Royal Oaks Subdivision

East Hampton, Connecticut

Environmental Review Team Report

Report No. 578

Figure 4

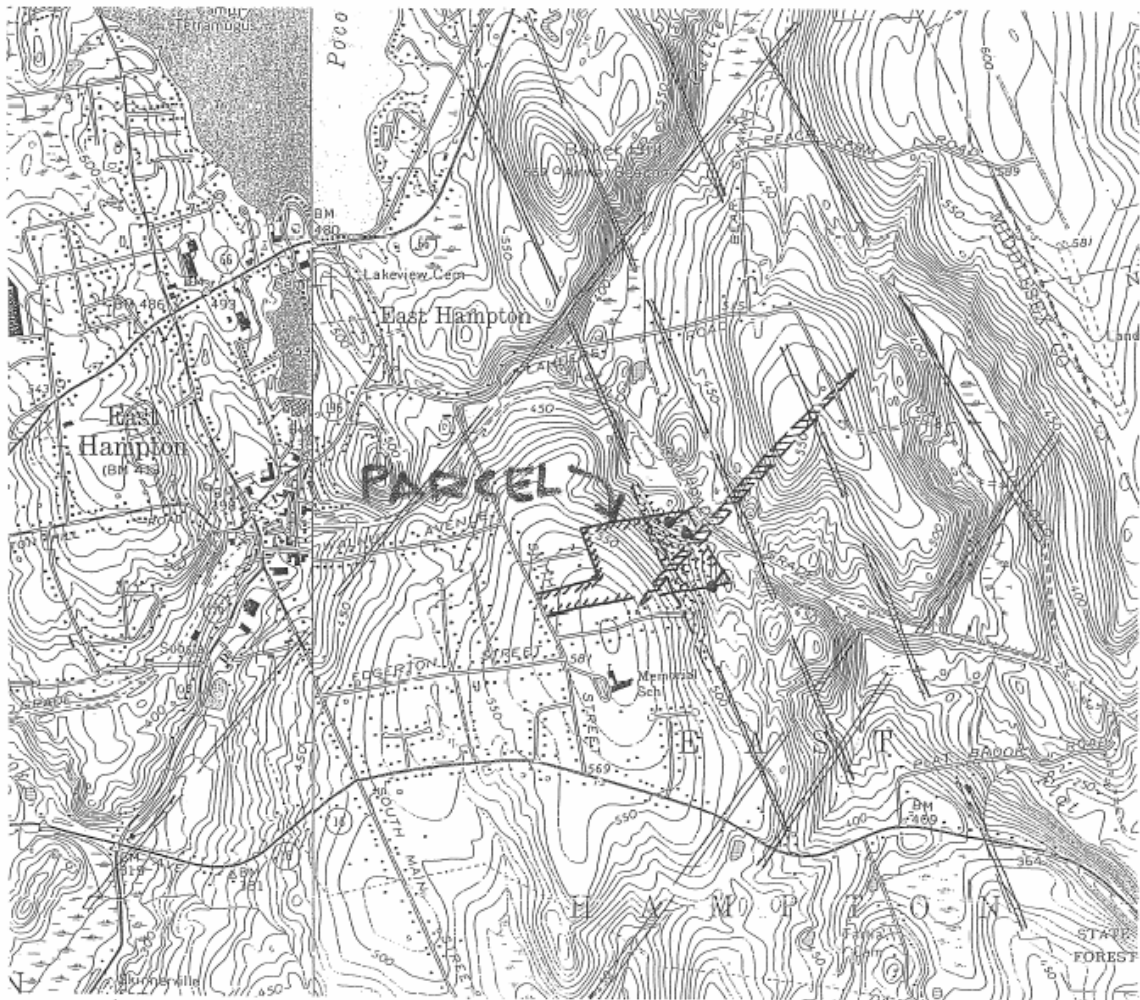
Erosion by the glacier is facilitated by fractures in the rock over which it moves. Summer melt-water seeps into fractures and refreezes, breaking the rock apart and forcing some into the flow of the glacier. Areas with numerous closely spaced fractures manifest themselves as straight aligned valleys and cliff faces. Some inferred fracture zones near the proposed development are indicated on the topographic map (Figure 4).

(Surface hydrology related to wetlands and water-courses will not be discussed here.) A community water system, proposed for the development, will be formed by drilling several wells into the bedrock. Water will seep into each well from the set of fractures that the well-bore intersects. The closer spaced the fractures the better the yield of water from the well. Based on the topography, it appears that the densest (closest spaced) fractures are near the base of the slope.

- A storm water retention basin is sited in an area where the till is thin and will likely require blasting for its construction. This will produce fresh unweathered rock of the Brimfield Formation and possibly some trap rock. The traprock, if encountered, is a valuable resource that could be crushed and used for road construction. The Brimfield Formation is less useful and will likely be deposited somewhere on site as a means of disposal. It contains fresh iron sulfides that rapidly will weather to form rusty acidic water (not unlike acid mine drainage water) which may be detrimental to local wetlands.

- Consideration might be given to locating the water wells further down hill from the area proposed on the development where fractures are expected to be denser and thus yields higher.

Figure 6
Traffic Counts by MRPA in April 2003

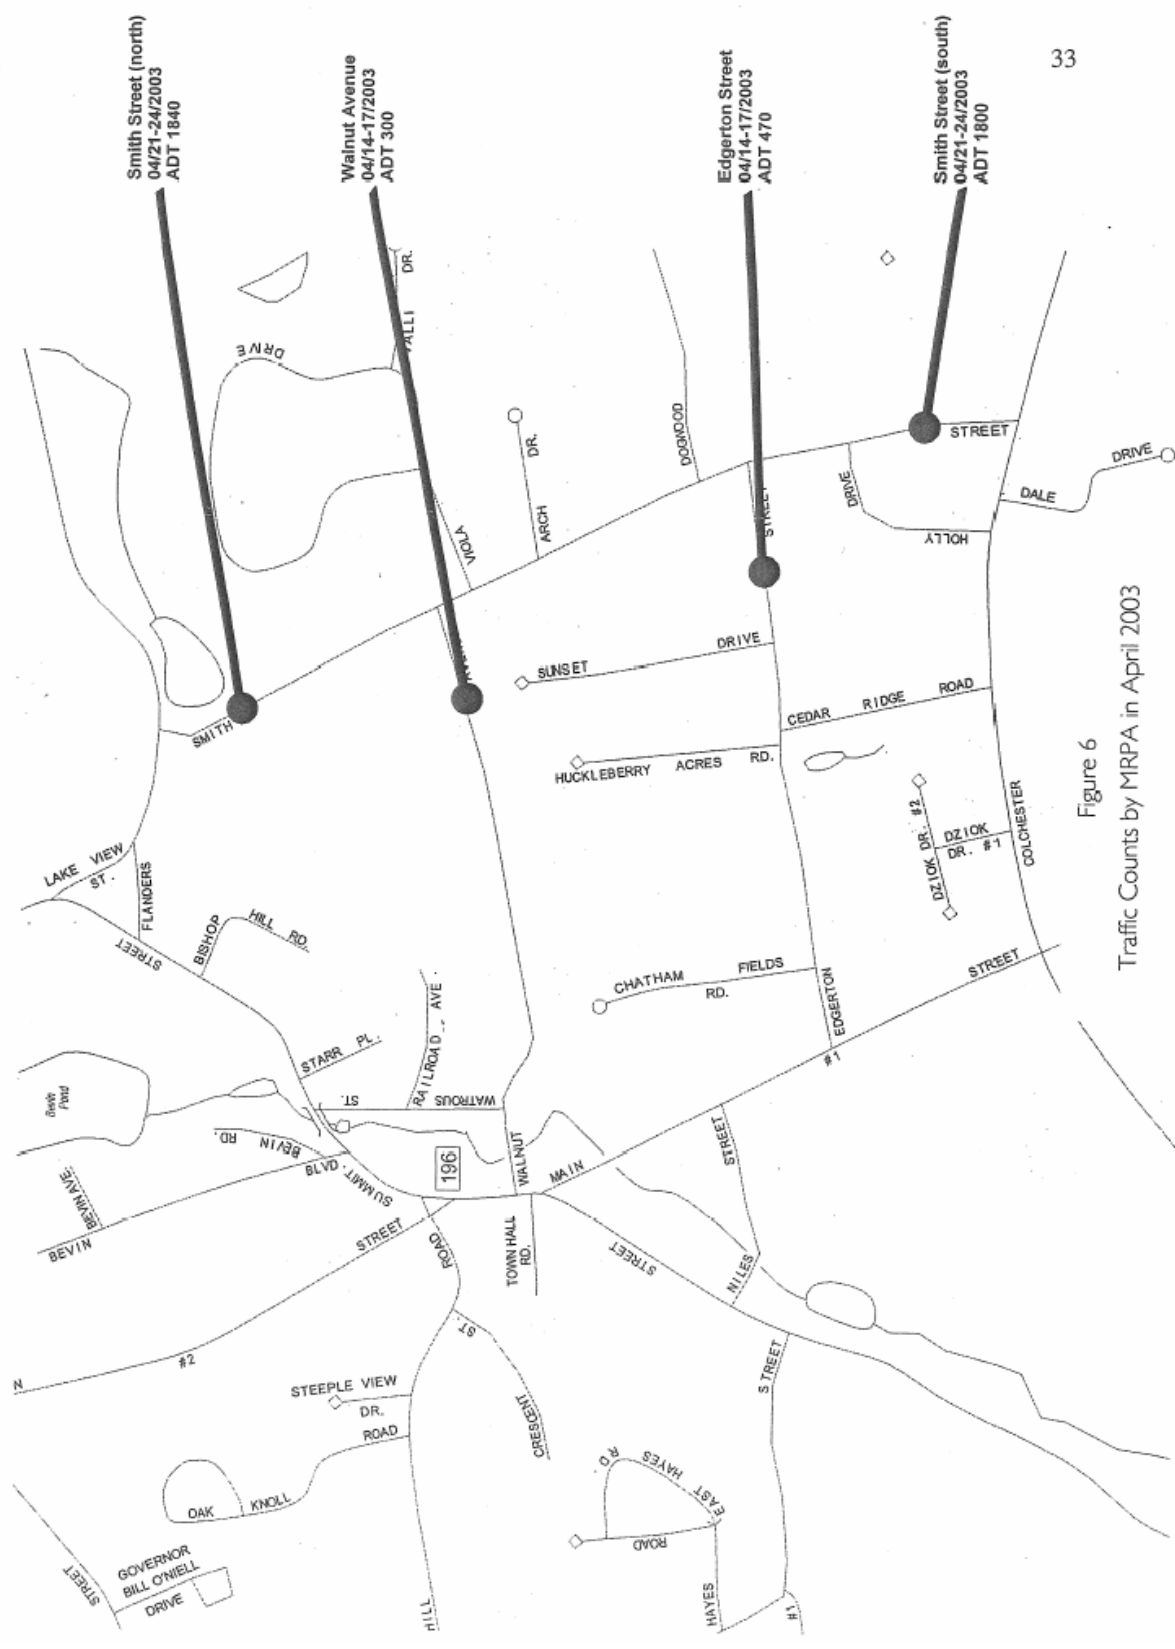
Traffic counts were performed by Midstate Regional Planning Agency (MRPA) in April of 2003 in the vicinity of the site. The average daily traffic (ADT) on the northern end of Smith Street was 1,840 vehicles per day and 1,800 on the southern end of Smith Street. Additional counts were taken on Walnut Avenue, where the ADT was 300 and on Edgerton Street where there was an ADT of 470. (See Figure 6)

The current maximum a.m. and p.m. peak hour volumes were 81 and 151 respectively on the northern end of Smith Street and 72 and 132 on the southern end of Smith Street. Provided that half of the traffic generated from the proposed development travels north and the other half travels south, then the a.m. and p.m. peak hours could increase to approximately 118 and 200 on the northern end of Smith Street and 109 and 181 on the southern end of Smith Street.

Figure 7
Traffic Counts by ConnDOT in 2000

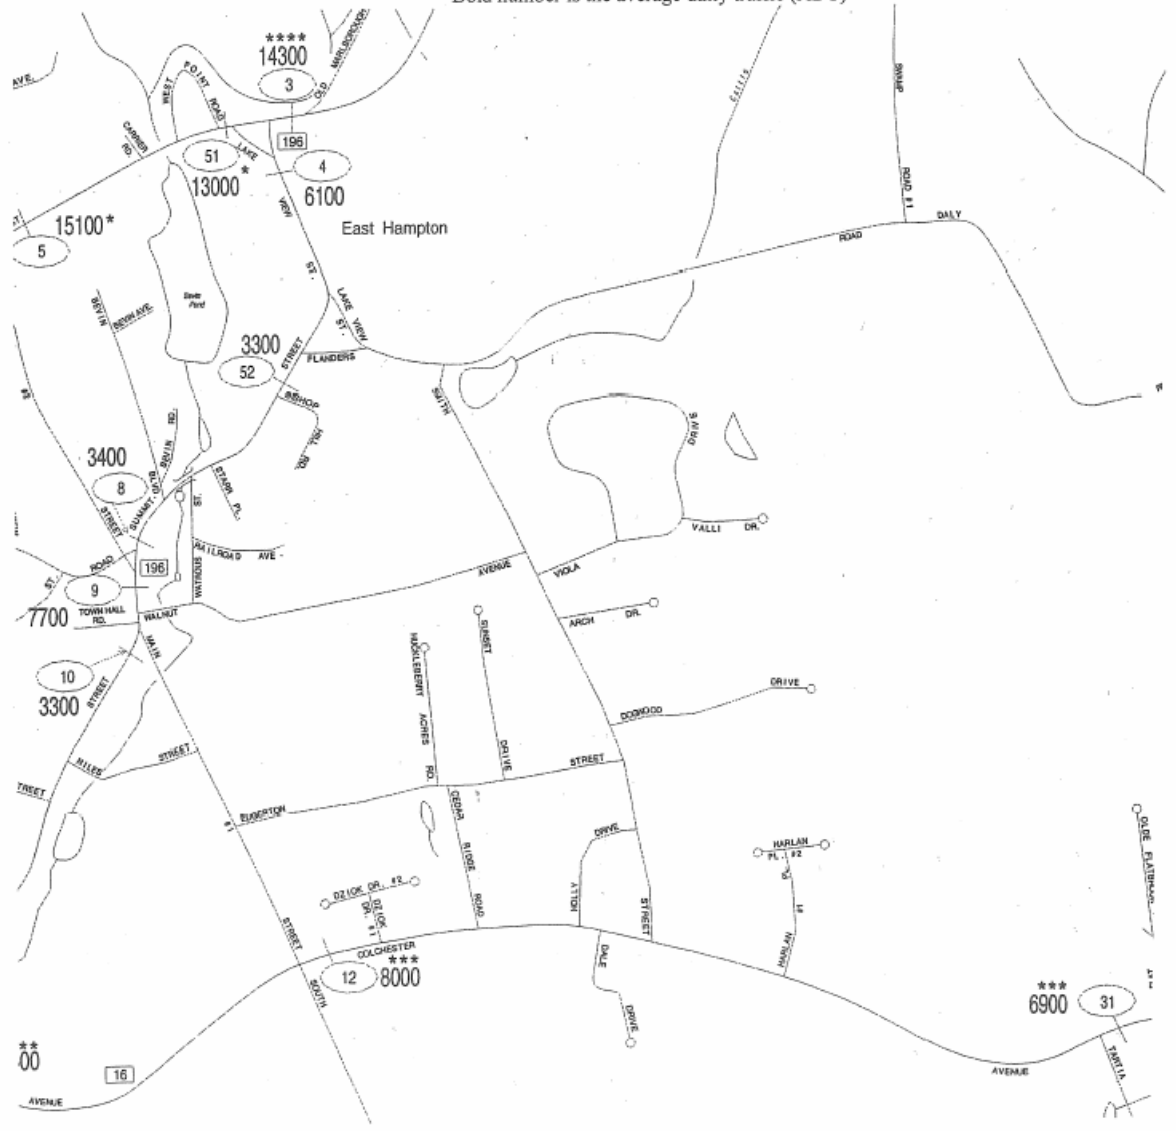
Traffic counts performed by ConnDOT in 2000 in the vicinity of the site include counts of 8,000 on Route 16 west of Smith Street and 6,900 east of Smith Street. Counts of 6,100 on Route 196 south of Route 66 and 3,300 south of Flanders Road were also taken in 2000. In addition, the ADT on Route 66 was 13,000 west of Route 196 and 14,300 east of Route 196. (See Figure 7)
